AMENDMENTS TO THE DRAWINGS:

REMARKS

The Applicant thanks the Examiner for the thorough review and consideration of the pending application. The Office Action dated December 16, 2008 has been received and its contents carefully reviewed.

Fig. 5

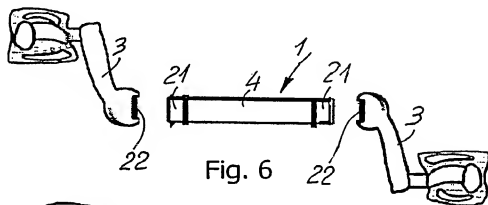
In Figure 5, reference number --19-- has been added. In Figure 11, reference number --29-- has been added. In Figure 21, reference number --51-- has been added. In Figure 26, reference number --58-- has been added. In Figures 27 and 28, reference number "61" has been amended to --62-- and reference number --66-- has been added to Figure 28. In Figure 40, reference number --83-- has been added and in Figure 41, reference number "83" has been amended to --86--. In Figure 44, reference numbers --97-- and --98-- have been added. In Figure 66, reference number "112" has been amended to --114--. In Figures 67, 68, 70, 71 and 74, reference number "38" has been amended to --118--. In Figure 69, reference number --124-- has been added.
